RE: Grant Creek Village Transportation Impacts

Greenlight Engineering has been asked by the Friends of Grant Creek and Rocky Mountain Elk Foundation to evaluate the transportation related impacts of the proposed Grant Creek Village Multifamily development in Missoula, Montana. We have reviewed the April 2022 Grant Creek Village Residential Development Traffic Impact Study 2022 UPDATE (hereafter referred to as the "TIS").

Figure 26. Current (2015) congestion on existing roadways

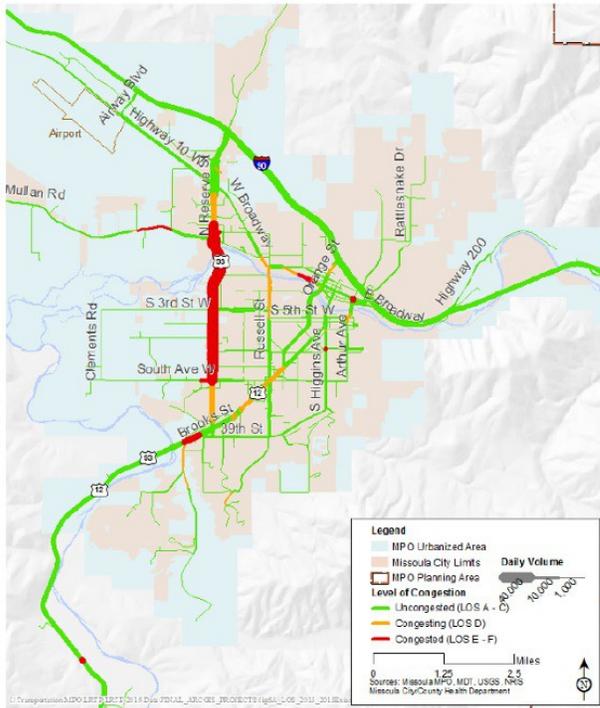
It is well known to the city that Reserve Street south of the I-90 interchange experiences congestion. This congestion is documented by the city in *Activate Missoula 2045 Missoula Long Range Transportation Plan*². In 2015, significant portions of Reserve Street were operating at LOS E to F, indicating operating failures as illustrated in Figure 26 below. Sometime between 2015 to

The development's impact on Reserve Street south of I-90 (2065 daily trips) is ten times the minimum threshold for requiring a traffic impact study (200 daily trips), yet there is absolutely no analysis of transportation impacts in that area. The lack of inclusion of any analysis of this area of Missoula, which is expected to experience significant congestion, is a major omission of the TIS that necessitates correction.

Figure 27. Projected 2045 congestion on existing roadways + committed projects

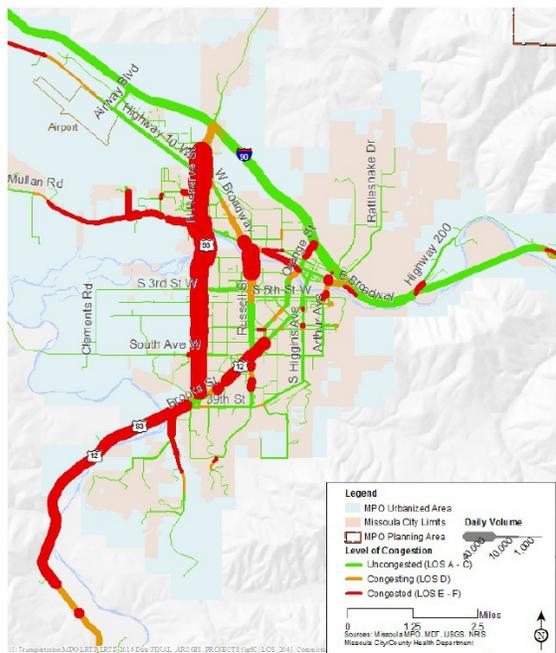
2045, the anticipated congestion significantly intensifies and spreads to the north near the I-90 interchange as illustrated in Figure 27 below.
